APPENDIX C6
COMMENTS RECEIVED

SCOPING PHASE

LIMESTONE SOLAR PV1 AND LIMESTONE SOLAR PV2 FACILITIES NEAR DANIELSKUIL, NORTHERN CAPE PROVINCE (DEFF Ref. Nos.: To be issued)

COMMENTS ON THE DRAFT SCOPING REPORT FOR THE PROPOSED DEVELOPMENT OF THE UP TO 150MW_p LIMESTONE PHOTOVOLTAIC (PV 1) FACILITY AND ASSOCIATED INFRASTRUCTURE, NEAR DANIELSKUIL, WITHIN THE KGATELOPELE LOCAL MUNICIPALITY, NORTHERN CAPE PROVINCE

Limestone 1 & 2 PV facility Northern Cape Province Locality Map

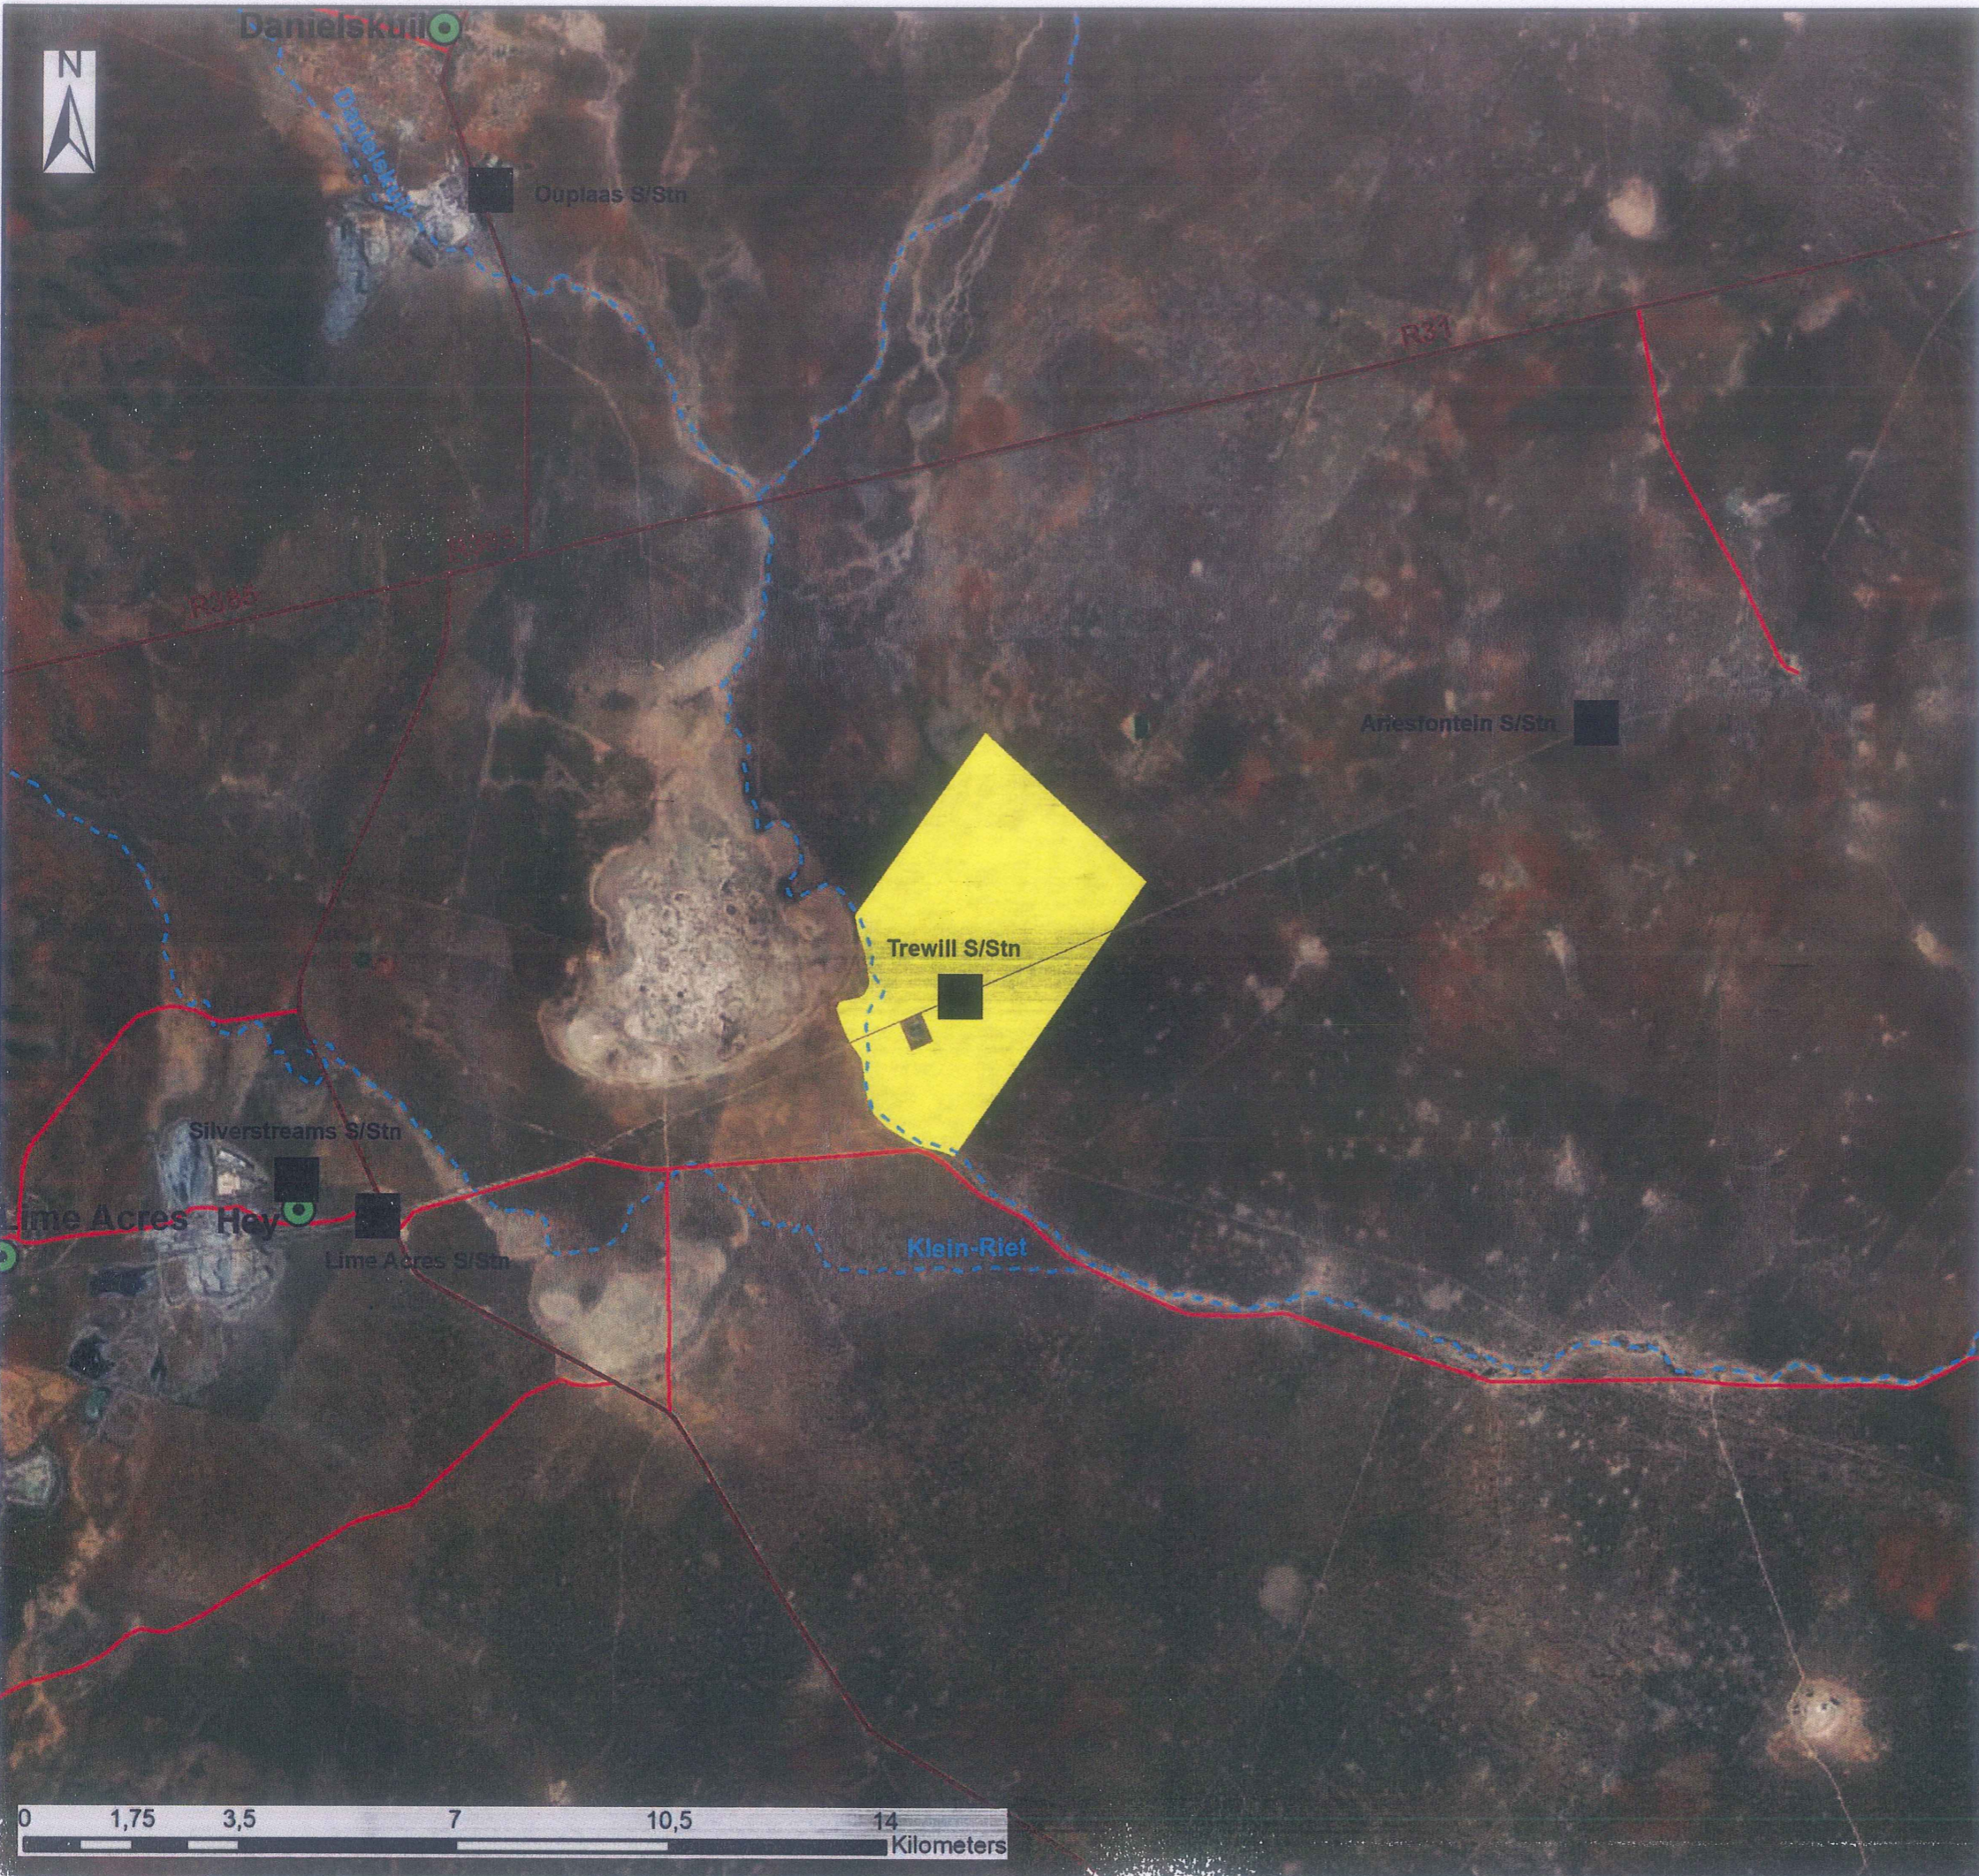
With reference to your above- mentioned application, I hereby confirm that the proposed work installation is approved in terms of Section 29 of the Electronic Communications Act No. 36 of 2005 as amended.

No infrastructure of our Client (Openserve) will be affected by this proposal. **We did our utmost to ensure that we indicate our route as accurate as possible and should you discover any of our cables that is not on the sketch please stop and contact us immediately to arrange a site meeting. In the event that our cables are exposed and damaged/stolen by a third party the damages will be repaired at the customer's account. Please make use of pilot holes in order not too damage our infrastructure.** Therefore any damages occurred during construction of work will be repaired at the customer's account.

FELKOM SA. LIMITED DECLARATION
NO COMPANY PLANT IS AFFECTED BY
THIS PROPOSAL.
